**SOAH DOCKET NO. 473-10-5546
PUC DOCKET NO. 38354**

APPLICATION OF LCRA TRANSMISSION SERVICES CORPORATION TO AMEND ITS CERTIFICATE OF CONVENIENCE AND NECESSITY FOR THE MCCAMEY D TO KENDALL TO GILLESPIE 345-KV CREZ TRANSMISSION LINE IN SCHLEICHER, SUTTON, MENARD, KIMBLE, MASON, GILLESPIE, KERR, AND KENDALL COUNTIES	§ § § § § § § § § §	BEFORE THE STATE OFFICE OF ADMINISTRATIVE HEARINGS
--	--	---

**LCRA TRANSMISSION SERVICES CORPORATION'S RESPONSE TO
CLEAR VIEW ALLIANCE'S FOURTH REQUEST FOR INFORMATION**

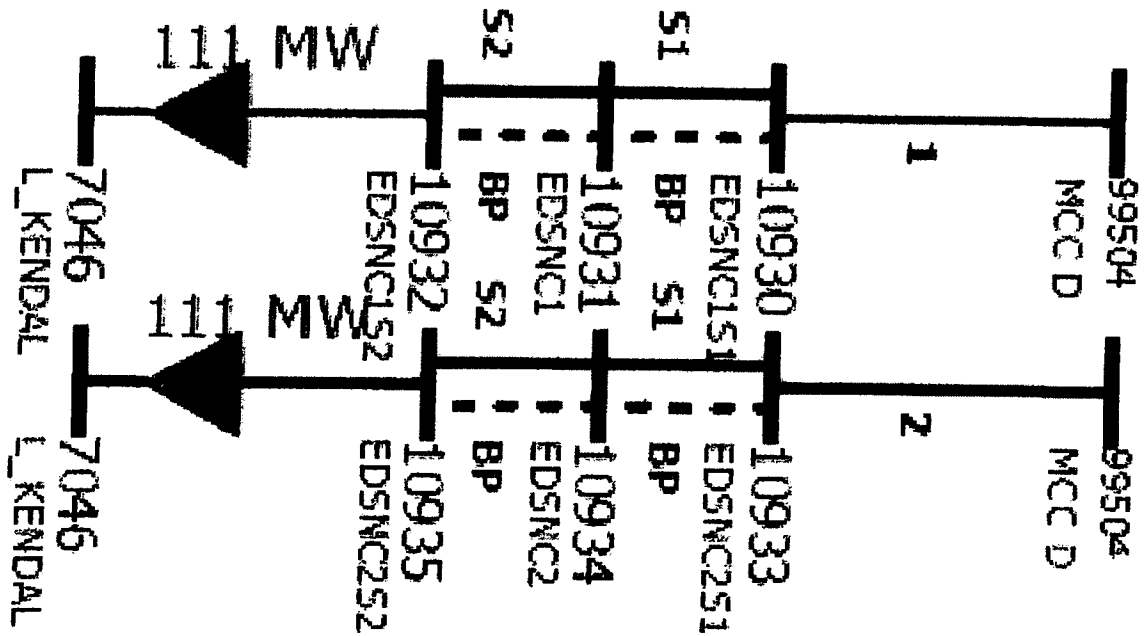
I would like to coordinate our data submission for the CREZ reactive study with someone at LCRA. Should AEP submit the data for the McCamey D-Kendal series capacitor in the IDEV to be sent to ERCOT for the reactive study?

Do you want AEP to include a 50% LTAP in the CREZ McCamey D-Kendal Line with a series capacitor modeled as describe above? The attached drawing shows the cap modeled the same way AEP modeled the other banks. Cathy Carter supplied a temporary bus number range to AEP for use in this study and the bus numbers for the series caps are in this range.

We are modeling the ETT series caps as two 25% segments with bypass switches around the middle 1/3 of the line. The middle of a line seems to be the best starting point for locating series capacitors. Modeling the series capacitor banks eliminates the need to adjust the line X by the amount of compensation. Two segments allow us to test different combination of levels of compensation.
